Access Compliance Report

Public Rights-of-Way

(Curb Ramps)

Intersection ID: 5854	Main Street: COMFREY_CT	Cross Street: PARTRIDGEBERRY_DR	Location: NE
ADA ID: 6743450CEF4B	Ramp Type: Perp	Initial Pass/Fail: Fail	Overall Compliance: No
Severity Score: 12.5			
Codes/Mitigation Info/Possible Solution		Field Measurements/Component Compliance

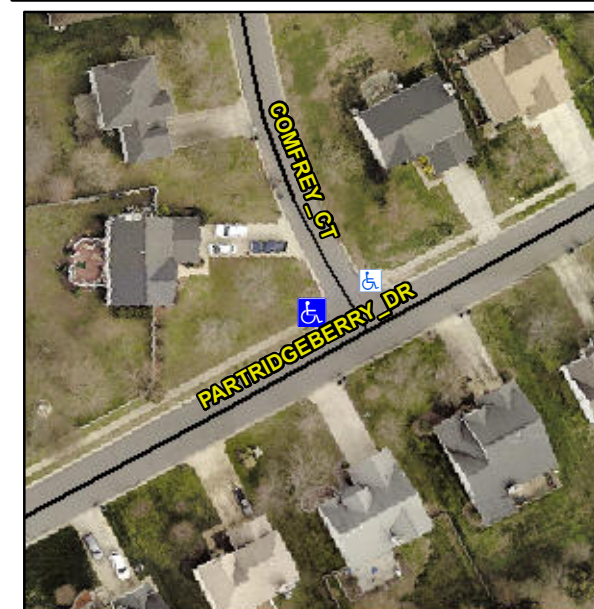
Not Found, R304.2.2

Compliance	Description	Data	Compliance	Description	Data
N/A	Ramp Length (in)	47.5	No	Ramp Slope (%)	10.3
Yes	Ramp Width (in)	89.5	Yes	Ramp XSlope (%)	0.3
N/A	Flare Type LT	N/A	N/A	Flare Type RT	N/A
N/A	Flare Slope LT (%)	N/A	N/A	Flare Slope RT (%)	N/A
N/A	Flare Traversable LT?	N/A	N/A	Flare Traversable RT?	N/A
N/A	Landing Length (in)	N/A	N/A	DWS Provided?	N/A
N/A	Landing Width (in)	N/A	N/A	DWS Contrast?	N/A
N/A	Landing Slope (%)	N/A	N/A	DWS Length (in)	N/A
N/A	Landing X Slope (%)	N/A	N/A	DWS Full Width?	N/A
N/A	Landing Curb? (Y/N)	N/A	N/A	DWS Offset (in)	N/A
N/A	Shared Landing?	N/A			
N/A	Gutter Ponding?	N/A	N/A	Gutter Slope (%)	N/A
N/A	Gutter Lip Ht (in)	N/A	N/A	Gutter X Slope (%)	N/A
N/A	Painted X Walk1?	No	N/A	Painted X Walk2?	N/A
	X Walk 1 Direction	To W		X Walk 2 Direction	N/A
N/A	X Walk 1 Width (in)	N/A	N/A	X Walk 2 Width (in)	N/A
	X Walk 1 Slope (%)	3.7		X Walk 2 Slope (%)	N/A
	X Walk 1 X Slope (%)	5.1		X Walk 2 X Slope (%)	N/A

Remove & Replace Entire Ramp.
